**CHARTER TOWNSHIP OF VAN BUREN
PLANNING COMMISSION AGENDA
Wednesday, February 13, 2019 – 7:30 PM
Van Buren Township Hall
46425 Tyler Road**

DATE: February 9, 2019
TO: Planning Commission
FROM: Ron Akers, AICP – Director of Planning & Economic Development
RE: SPR 19-005 Site Plan Amendment for Trowbridge Homes regarding Architectural Elevations in the Cobblestone Ridge Development.

DATE: February 9, 2019
TO: Planning Commission
FROM: Ron Akers, AICP – Director of Planning & Economic Development
RE: SPR 19-004 Site Plan Amendment for BK Development in Cobblestone Creek Review.

DRAWN:	DESIGNED:	CHECKED:
BKA	BKA	GA
SCALE : 1/4" = 1'-0"		
FILE NAME : 18075_A.202		
JOB # : 18075		
SHEET TITLE A-201 UPGRADE ELEVATIONS OPTION "D" SHEET # A-202

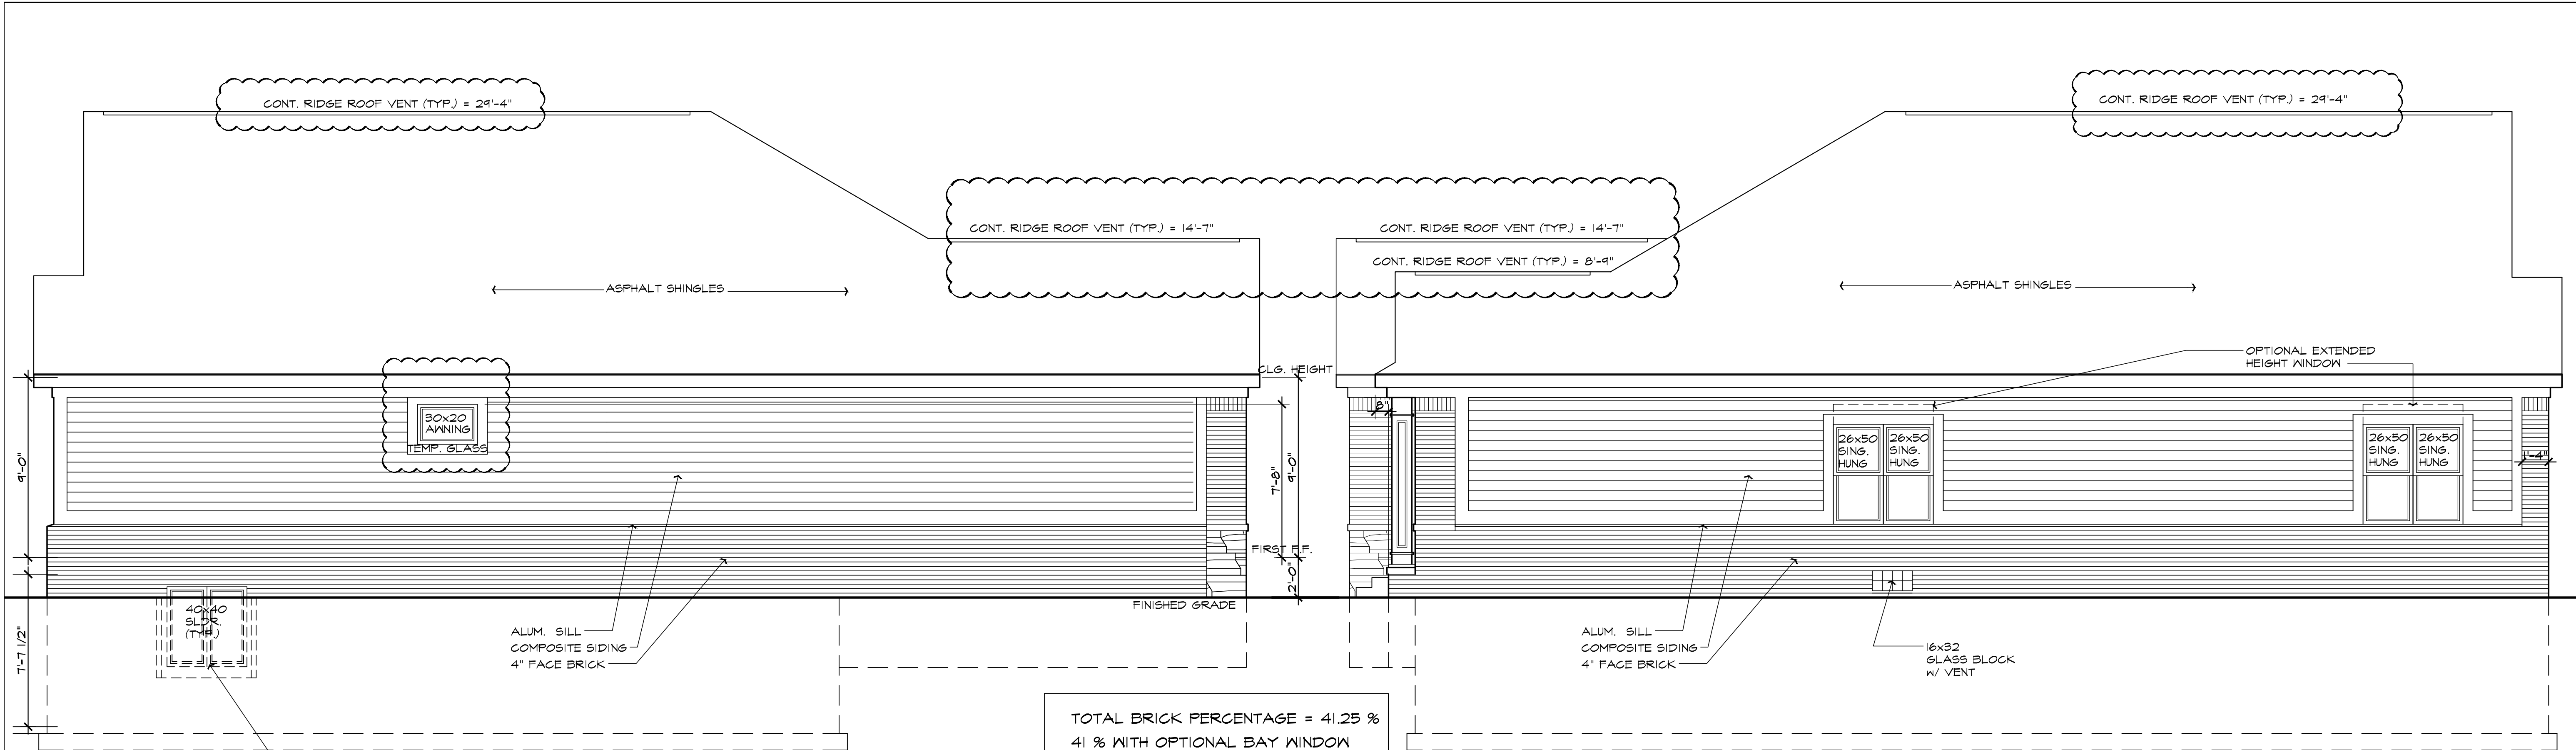
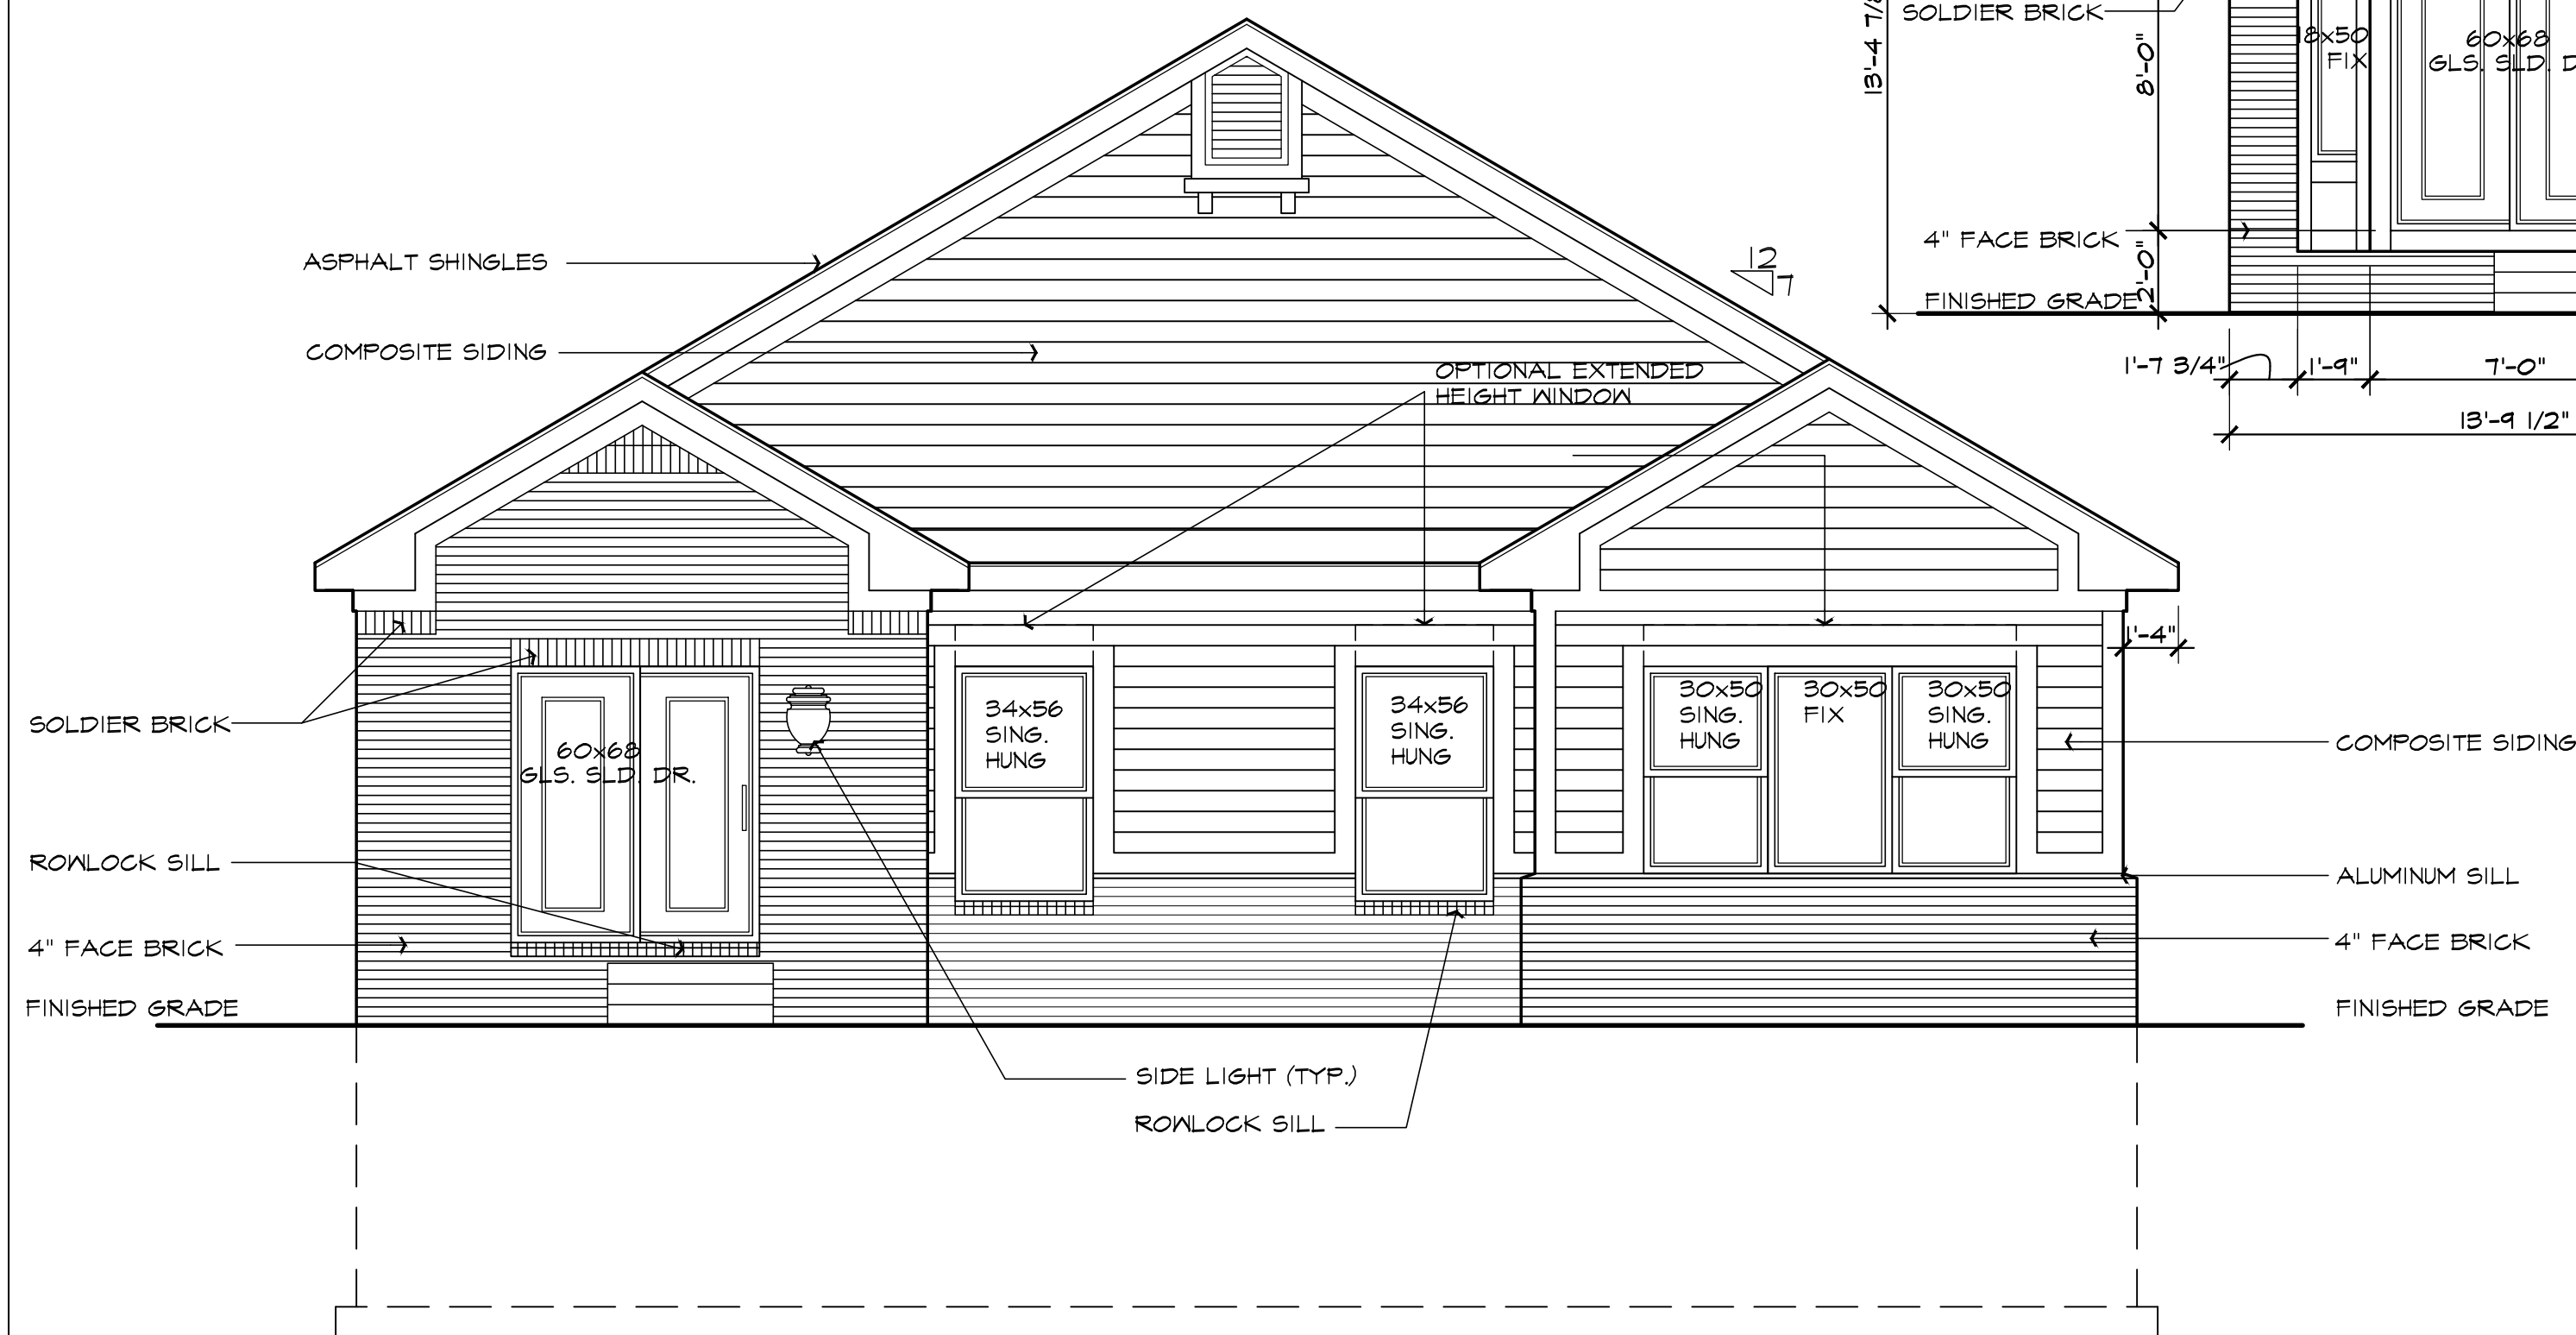
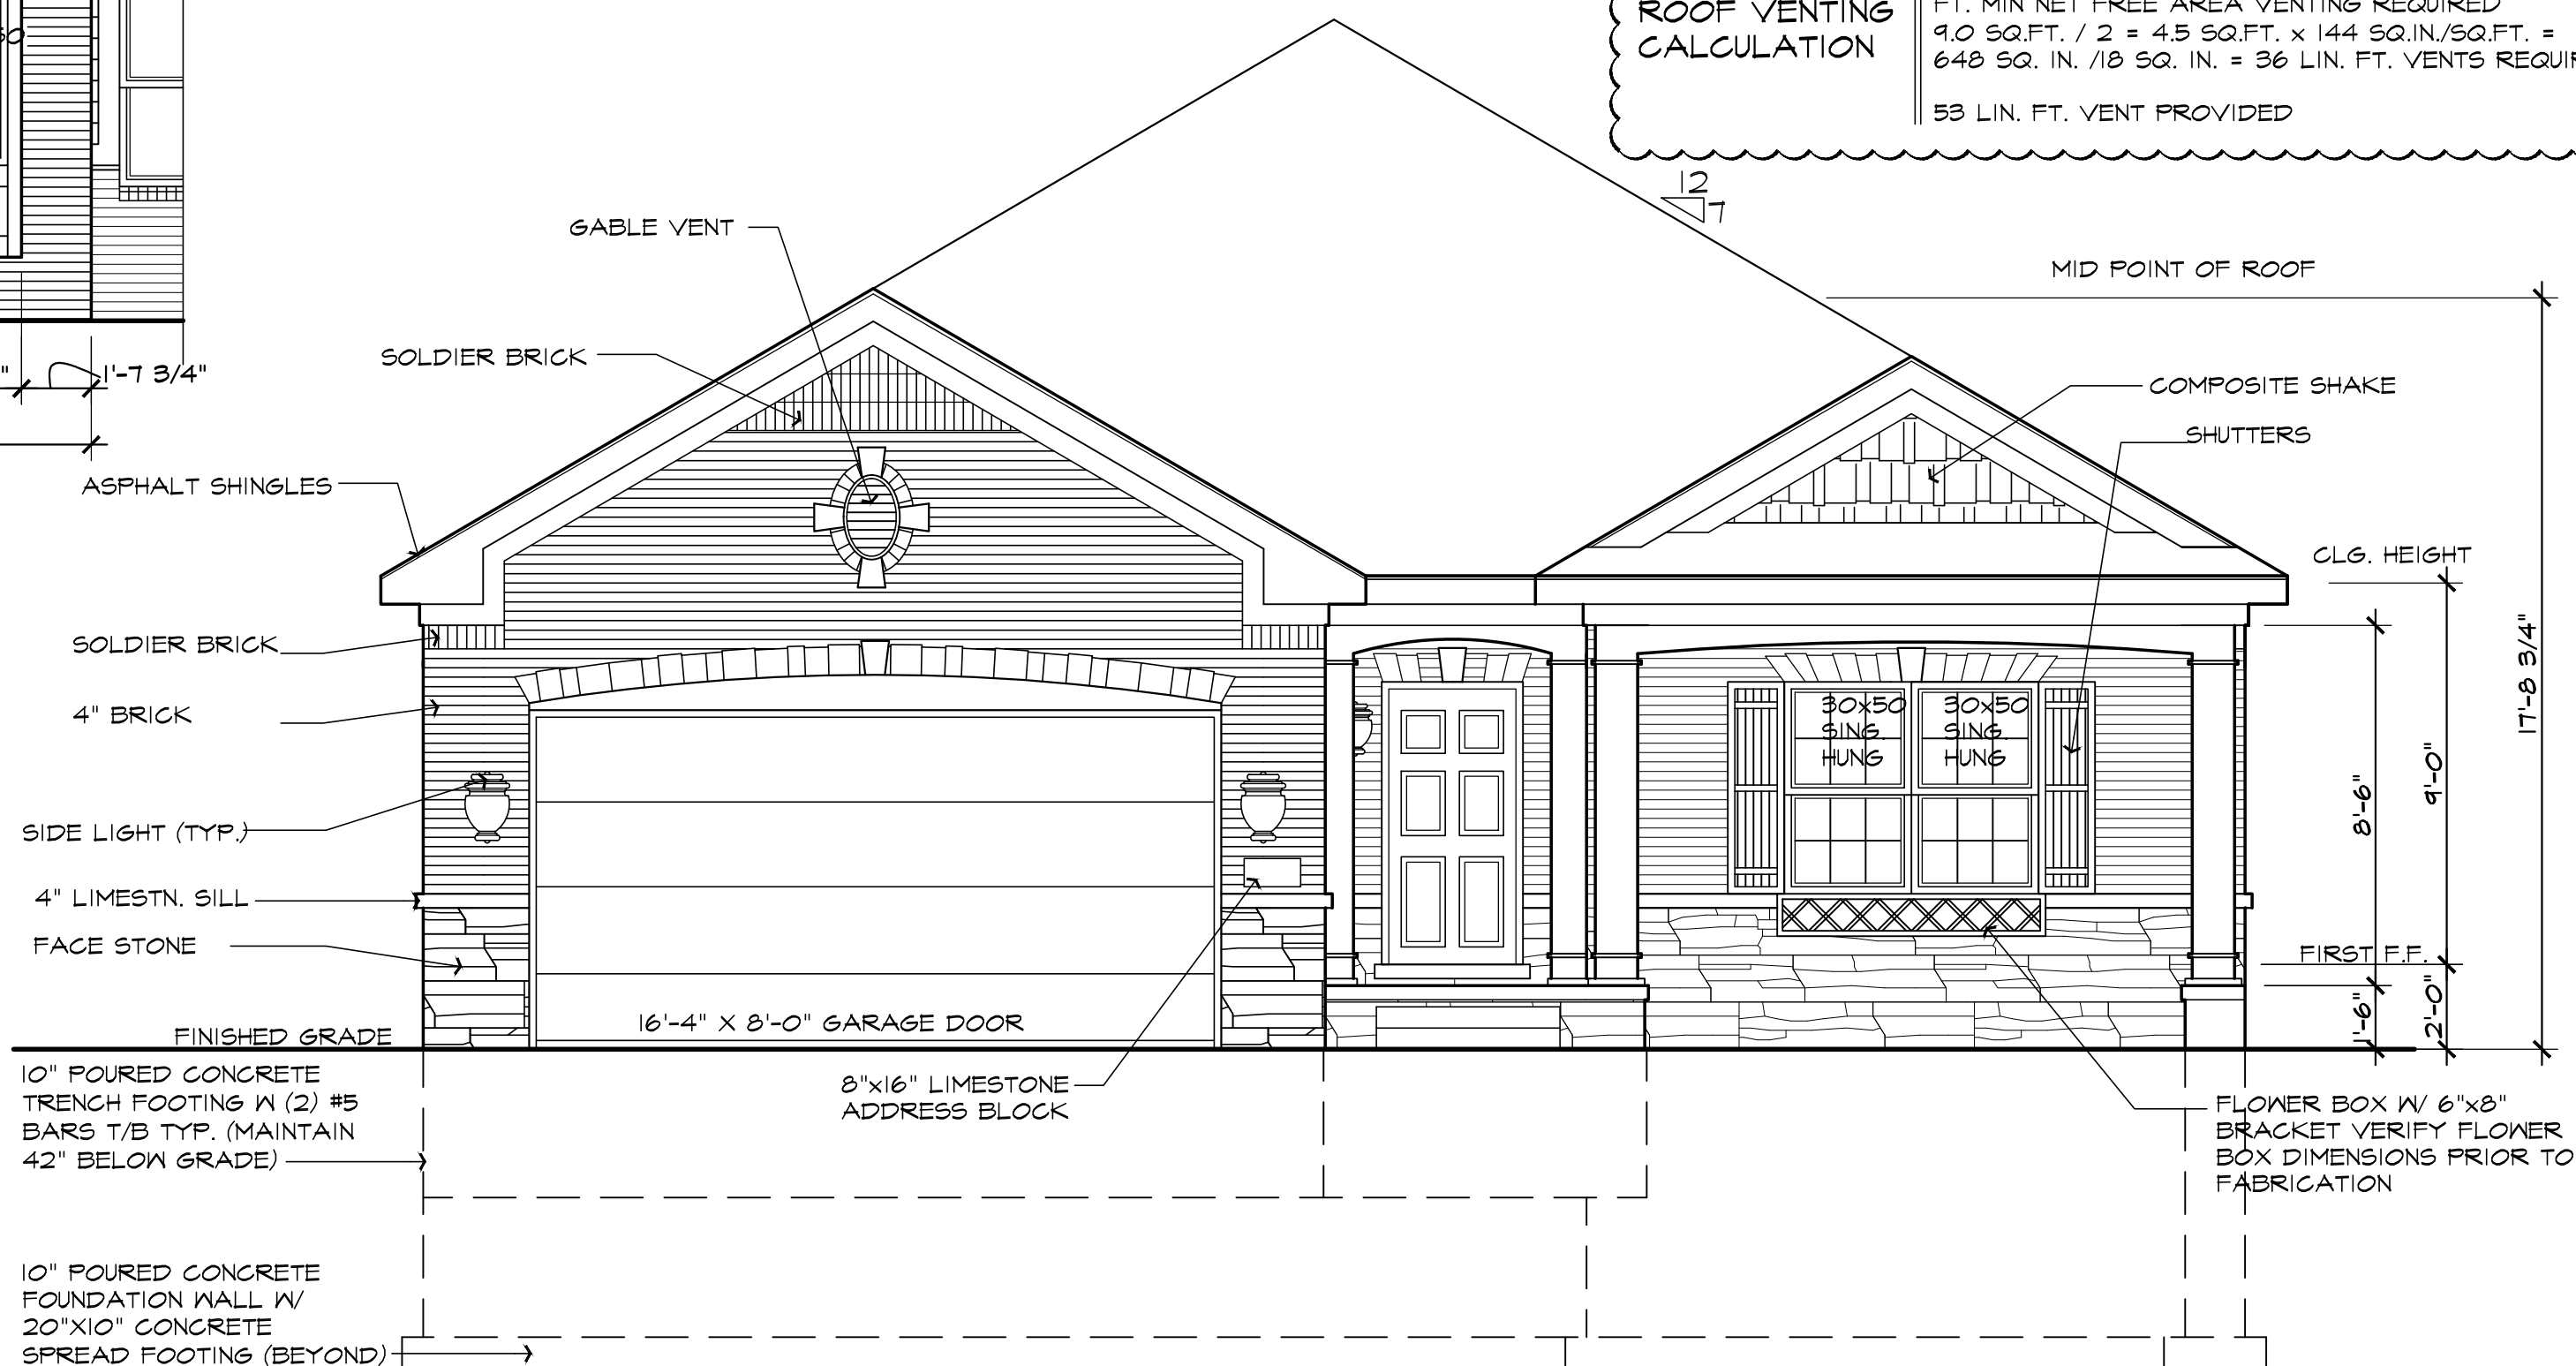
Based on the provided plans it does not appear that the total percentage of exterior material (total area of all walls minus the area of windows, doors, and gable ends) would meet the 50% requirement, but the applicant would easily be able to achieve this by making modifications to the plans in order to reflect this. I would recommend that the Planning Commission require that this item be satisfied as a condition of approval.

1. That the applicant provides a revised plan which depicts the detached unit having a minimum of 50% brick, stone, or other decorative material on the exterior façade of the entire building measured by taking the total area of all walls minus the area of windows, doors, and gable ends.
2. Township Planning Staff shall review each application for a new single-family home in the Cobblestone Creek development in order to determine that the new home meets
